RE: REPLY COMMENTS
2023 INTEGRATED DISTRIBUTION PLAN
DOCKET NO. E002/M-23-452

IN THE MATTER OF XCEL ENERGY'S
2023 INTEGRATED DISTRIBUTION PLAN

DOCKET NO. E002/M-23-452

REPLY COMMENTS

Figure 1
The Company's Hosting Capacity Map, Showing Available Hosting Capacity by Location¹⁴

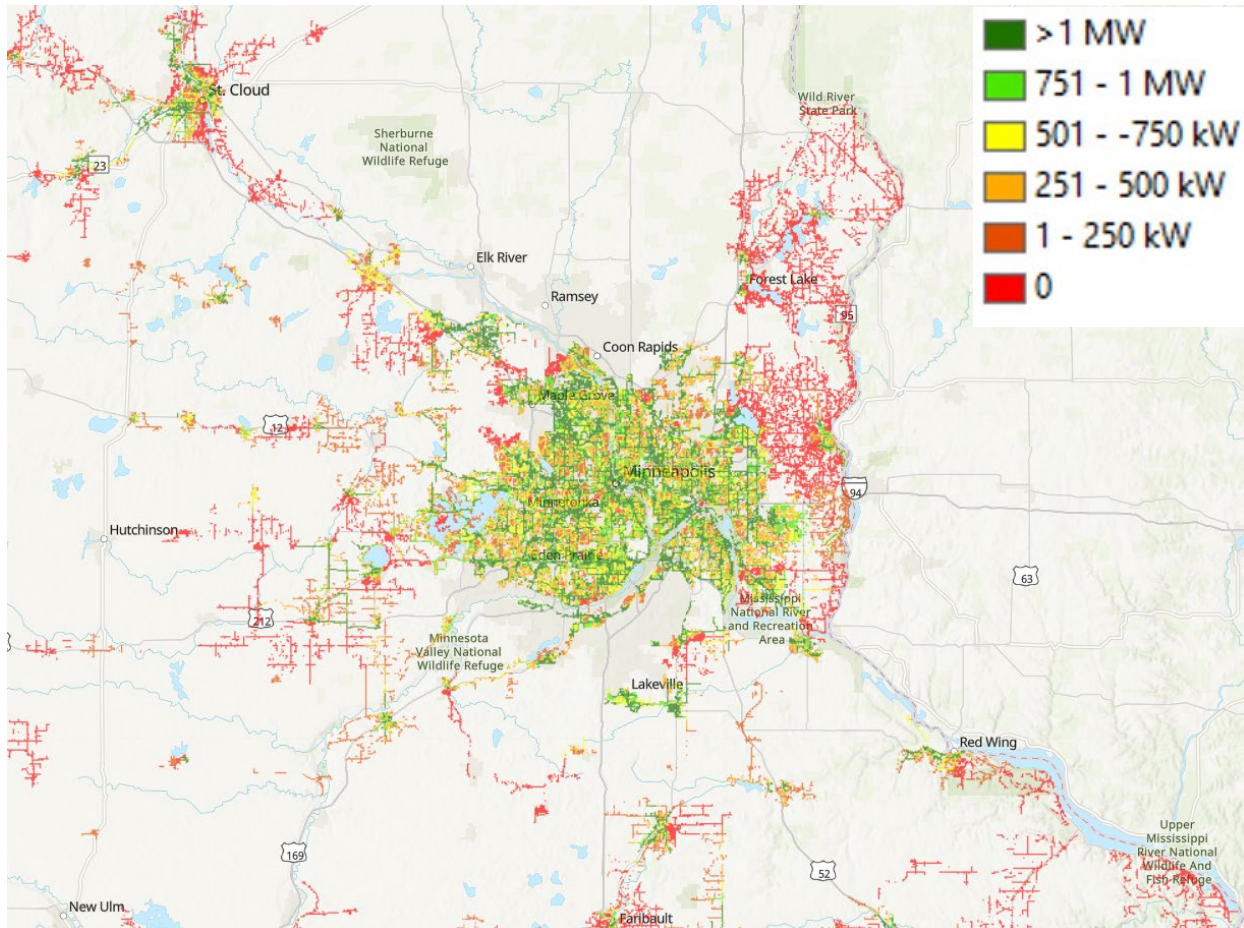
The GECs and the City of Minneapolis also commented on equity in hosting capacity and the need to plan grid investments so that adequate hosting capacity is ensured in neighborhoods that have a high percentage of people of color. As indicated in Figure 1 below, the Company’s Hosting Capacity Map generally shows more hosting capacity in the Twin Cities Metro Area, which contains the neighborhoods with the highest proportion of people of color. Suburbs outside the Metro Area and rural areas are

more frequently lacking hosting capacity, as indicated on the map in red. This is due to the rapid growth of CSGs (currently just over 900 MW) in our service territory, which have exhausted the available hosting capacity on many suburban and rural substations and feeders. Additional capacity cannot be added to these substations and feeders without expensive grid upgrades. The GECs cite similar results from the Pradhan and Chan Study, which shows significantly higher average area hosting capacity (in kW) as well as significantly higher hosting capacity per household in Hennepin and Ramsey counties and in disadvantaged neighborhoods. Hosting capacity is also higher in communities within the top 10 percent of population being people of color.

Figure 2
2023 IDP- Illustrative Long-Term Grid Modernization Plan

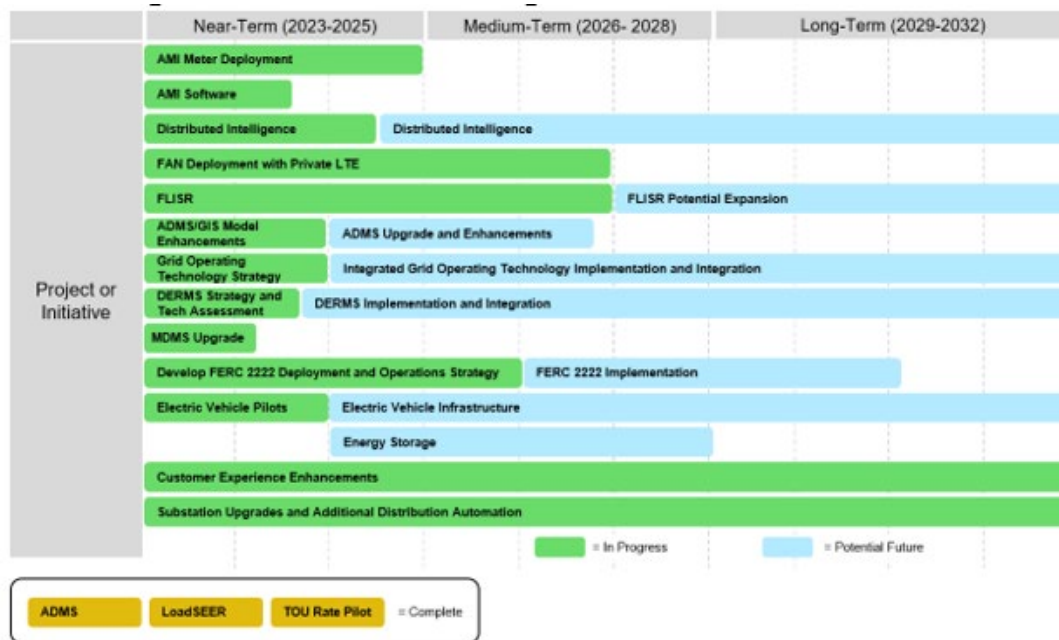
The Department made an overall recommendation that the Company should refile *Appendix C: Action Plans* with all required information on grid modernization, including CBAs for each near-term project.³⁵ However, several near-term projects in Figure 2 are related to AMI, FAN, FLISR, and ADMS, which have already been certified and are being implemented. The illustrative plan also includes several near-term initiatives that are related to developing strategy for future, such as the “Grid Operating Technology Strategy,” “DERMS Strategy and Tech Assessment,” and “Develop FERC 222 Deployment and Operations Strategy” Projects. A CBA is not appropriate for these types of strategic initiatives. Similarly, “Customer Experience

Enhancements” and “Substation Upgrades and Additional Distribution Automation” are large placeholder buckets for various types of future investments that have not yet been developed into distinct, concrete projects. The Company believes that a CBA would not be appropriate or provide meaningful information for these types of initiatives. Requesting a CBA for all near-term projects/initiatives displayed in the illustrative roadmap would be premature and, in many cases, not possible particularly for projects still in the planning stage. Therefore, we oppose the Department’s recommendation to re-file *Appendix C: Action Plans*.
